ALERT SERVICE BULLETIN

206-07-115

MODEL AFFECTED: 206A/B and TH-67

SUBJECT: POWER TURBINE RPM (N2) STEADY STATE OPERATION AVOIDANCE, INTRODUCTION OF.

Figure 1 - Typical 206B Instrument Panel Layout
(May vary depending on model and serial number applicability)

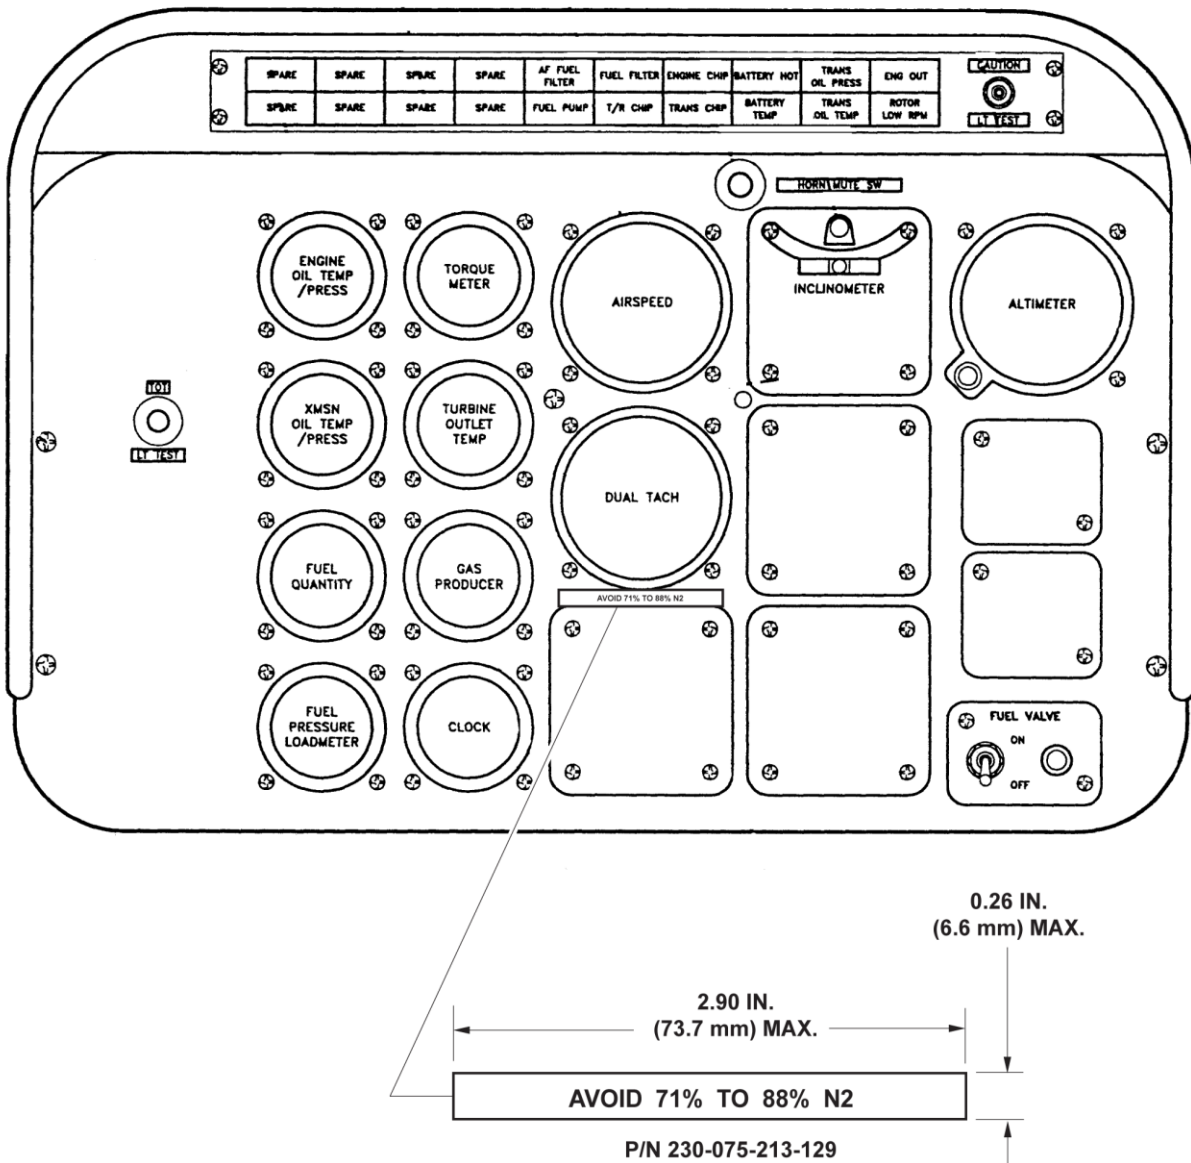
Revision D is a complete reissue of this Alert Service Bulletin (ASB). Rolls-Royce Corporation has revised the maximum allowable output shaft speeds for Series II engines (250-C20, 250-C20B, and 250-C20J). The new tables have been revised to include the power turbine RPM (N2) speed avoid range between 71% and 88%. Refer to Rolls-Royce ALERT CEB A-1400 Revision 6 dated April 12, 2018. **Revision D** of this bulletin provides the instructions to install the new decal 230-075-213-129 to affected helicopters.

NOTE 1: The decal may be locally manufactured using lettering of white color (No. 17875) on black background color (No. 17038). Characters to be 10 point Spartan Blackfont and color per FED STD 595. The text for the decal is detailed in Figure 1 and should be in capital letters.

1. Prepare helicopter for maintenance.
2. Remove existing 230-075-213-125 decal from instrument panel. Clean the area with aliphatic naphtha (C-305) (BHT-ALL-SPM, Chapter 8).
3. Install 230-075-213-129 decal on the instrument panel below the Nr/N2 RPM dual tachometer indicator. Apply edge sealer (C-349) over the installed decal (BHT-ALL-SPM, Chapter 8).
